Location: 1140 S. 5th St.

Project Name: High Country Gas & Supply

**FILE #** 212-94

**TITLE HEADING:** Site Plan Review  
High Country Gas

1140 South 5th

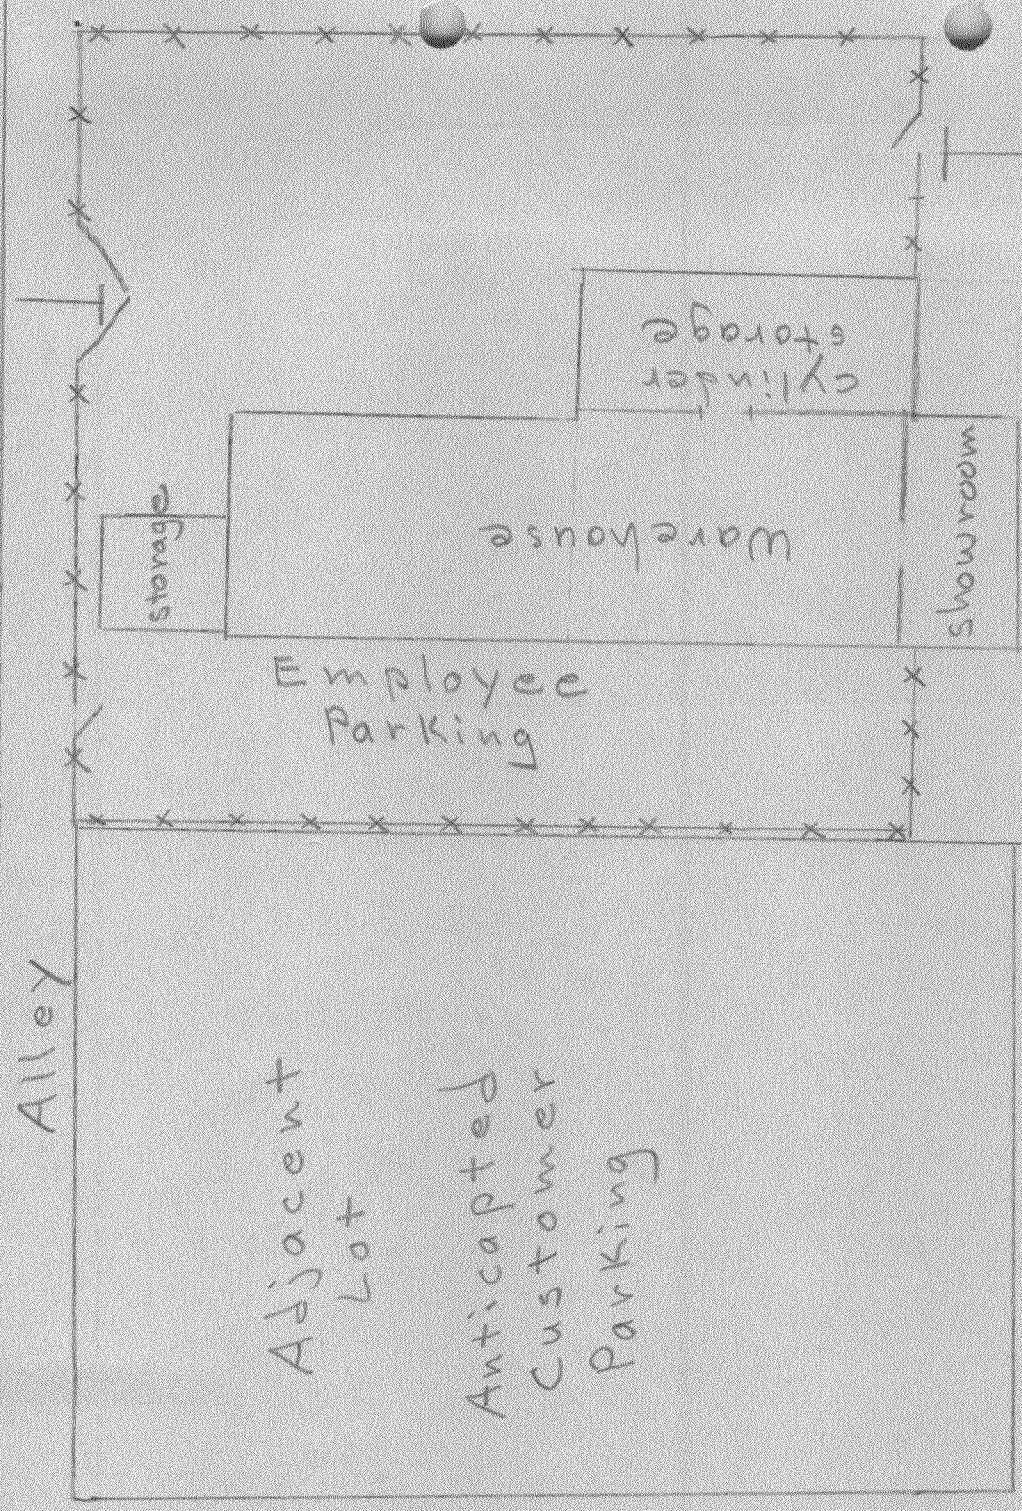
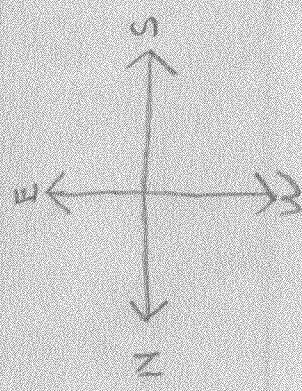
The Transportation Capacity Payment for this type of business would be \$753.00 based on \$305.60/1000 sq. ft. but the previous roofing business would have required \$944.53 as a single tenant office; thus no Transportation Capacity Payment is required. Need a parking plan, see attached diagram.

Applicant must submit a site plan and building floor plan showing location of welding operations, locations of indoor and outdoor storage areas for acetylene, oxygen and other compressed gases along with the maximum amounts to be stored and used. If liquid oxygen is to be stored or used, show location and amounts.

The total parking requirement is based on the number of employees for the warehouse and light fabrication use and the square footage of the retail display area. The number of employees as indicated in the narrative is 4. The number of spaces required for the retail display area is 3

based on a showroom area of 544 square feet. Therefore the total number of off-street parking spaces required is 7. The site plan must show how seven spaces will be designated on the site. Please refer to the attached guidelines for parking stall dimensions.

A parking plan must be submitted and approved showing the 7 required parking stalls.
